ADDENDUM NO. 01

DATE: March 10, 2026

FOR PROJECT: City of Cole Camp Maple St. Sidewalk Improvements TAP-9901(558)
GRE: 5107

N MAPLE ST SIDEWALK PLAN & PROFILE

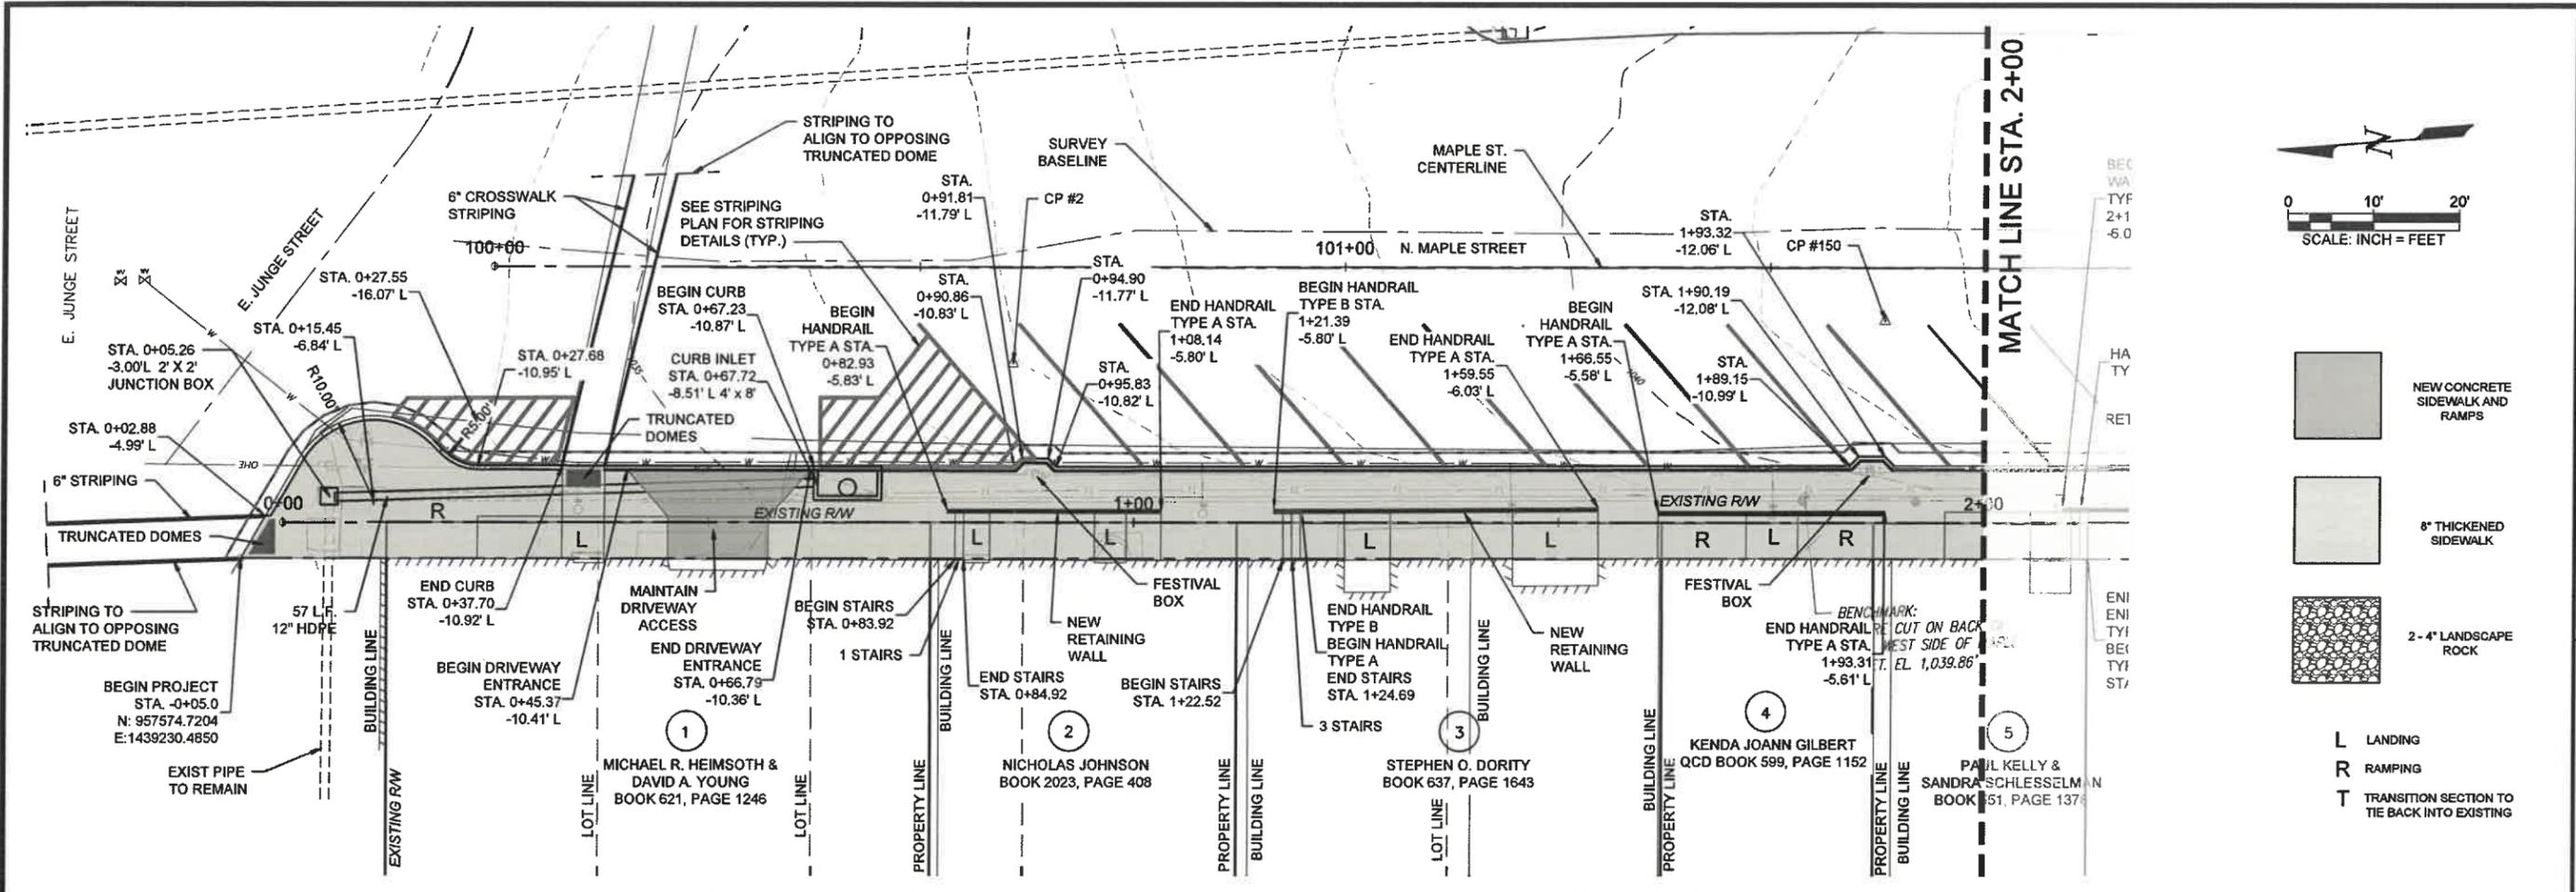
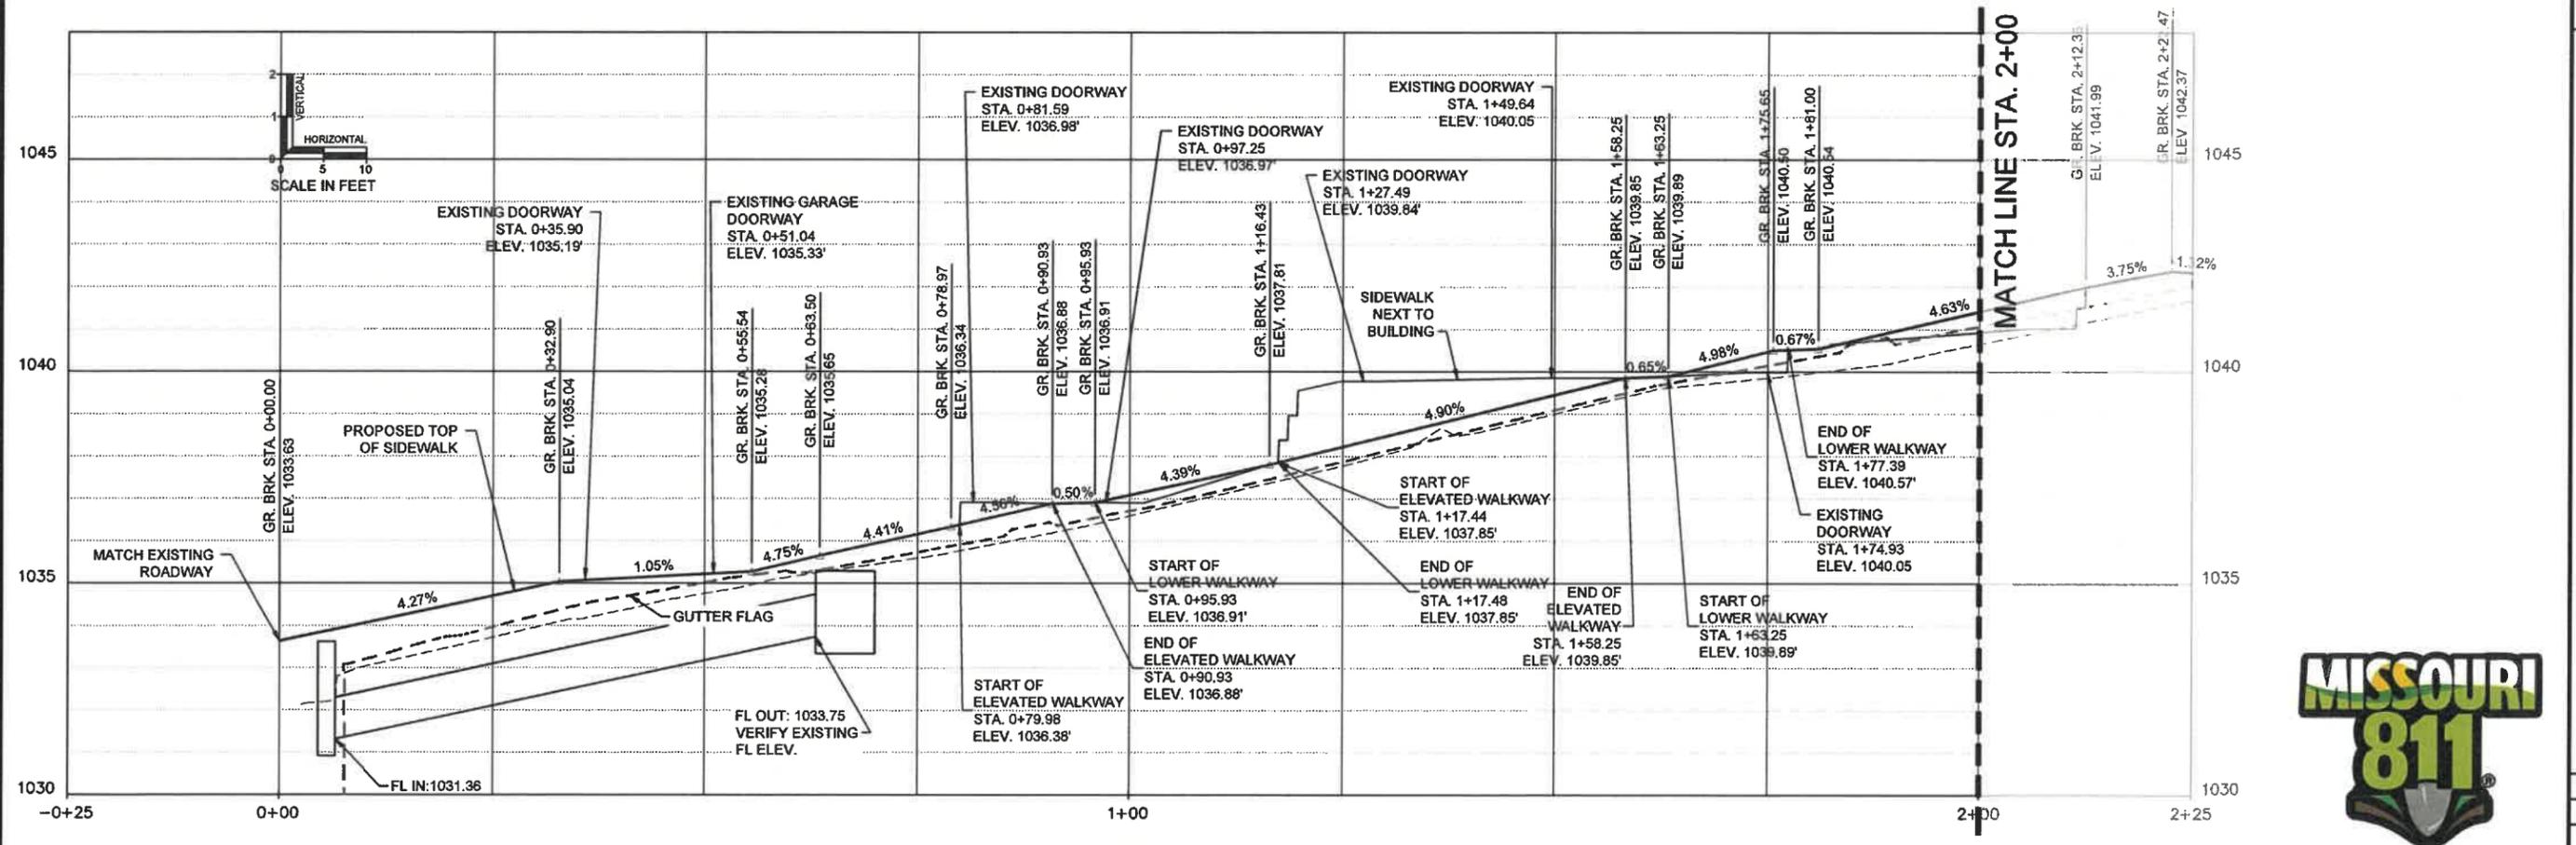
Modifications to STA 1+66.55 – STA 1+93.31 to address existing door and elevations via ramps in leu of stairs and added Handrail Type A.
